Office Action Summary

10/677,850

RAYNOR ET AL.

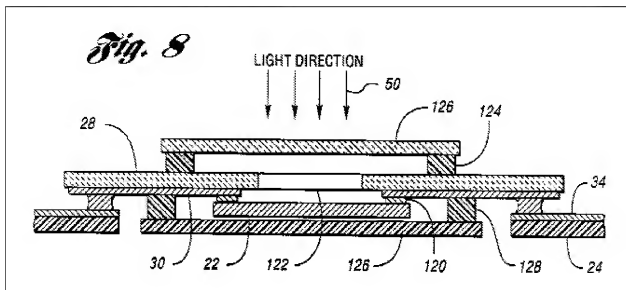
Bauer does teach the use of bump bonding using solder bump 120 in attaching an optical sensor 22 to a mounting base substrate 28 that comprises circuitry (e.g., conductive strip 30) (see, e.g., col. 10, line 61 – col. 11, line 10; col. 12, lines 41 – 59; figure 8). As shown in figure 8, the optical sensor 22 is aligned and mounted on the substrate 28 comprising opening 122.
